# **FIRE SAFETY INSPECTION REPORT**

## **UNIVERSE KNITTING GARMENTS**

**ACCORD ID: 12368**

November 14, 2015

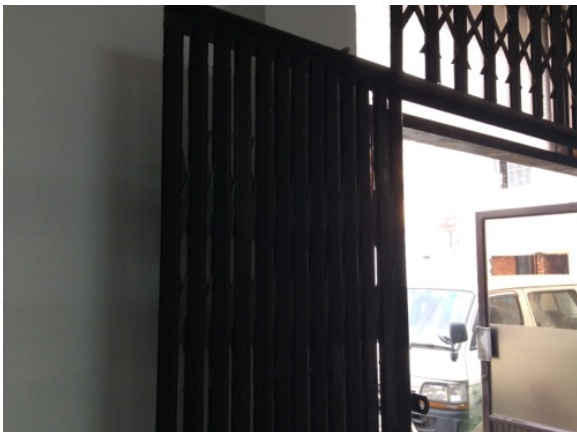
F-2	Egress	Egress doors / gates with locking features are provided at building exits, along egress routes and exit discharge.	Remove locking features from all egress doors / gates.  If locks are required for security reasons, utilize special door locking features complying with ACCORD standard 6.8.2.	Immediately
